**Re: Engineering Review #1
The Villas at Wayne Hills
Block 2329, Lot No. 1 & 17
1361 Alps Road, Wayne, NJ
Langan Project No.: 100925301**

We are in receipt of your memorandum dated October 20, 2022 regarding the The Villas at Wayne Hills major site plan and subdivision application.

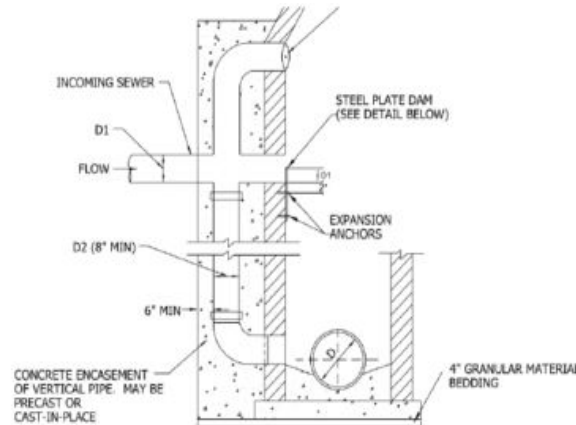
Under the NJ Condominium Services Act, the Township is not responsible for the maintenance of sanitary sewers on site. We note that the proposed sewers have drop manholes of up to 10 ft.

which can be problematic for idea flow. An alternate construction detail can mitigate its effects of waste obstructing flow such as shown below:

A drop manhole detail has been added to Drawing CU502. The individual pre-packaged low-pressure lift station for each dwelling unit will be adequately sized based on anticipated demand and potential outages.
